Sequoyah Nuclear Plant, Unit 1 and 2
Facility Operating License Nos. DPR-77 and DPR-79
NRC Docket Nos. 50-327 and 50-328

Subject: **SEQUOYAH NUCLEAR PLANT– REVISION TO THE REACTOR
PRESSURE VESSEL SURVEILLANCE CAPSULE WITHDRAWAL
SCHEDULE FOR LICENSE RENEWAL**

Request for Revision to Reactor Vessel Material Surveillance Capsule Withdrawal Schedule for Sequoyah Nuclear Plant Unit 1

Figure 5.4.3-3 Surveillance Capsule Plan View

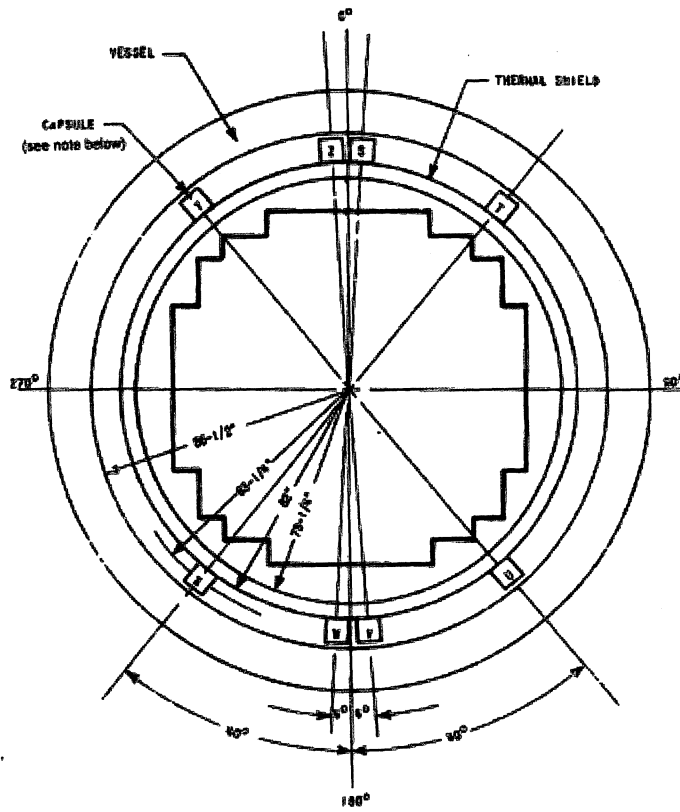
Relocation of Unit 1 reactor vessel surveillance Capsule V from the 176-degree azimuthal location to the 140-degree azimuthal location, a higher fluence location is required to support the proposed alternative capsule withdrawal schedule.

TVA is planning to relocate Capsule V in Unit 1 EOC 21, 22 or 23. The proposed revised Unit 1 schedule is to withdraw the relocated Unit 1 Capsule V (140-degree location after relocation from location 176-degree) during the EOC 31 (see FSAR Figure 5.4.3-3 below for location azimuths).

In summary, TVA is planning to relocate the Unit 1 Capsule V from the current 176-degree azimuthal location to the 140-degree azimuthal location at either EOC 21, 22 or 23. TVA is proposing a revised Unit 1 Capsule V withdrawal schedule to support the application for a SQN Unit 1 renewed license. The proposed revised schedule is to withdraw the relocated Unit 1 Capsule V during the EOC 31 outage. The remaining Capsule Z in Unit 1 will remain in standby.
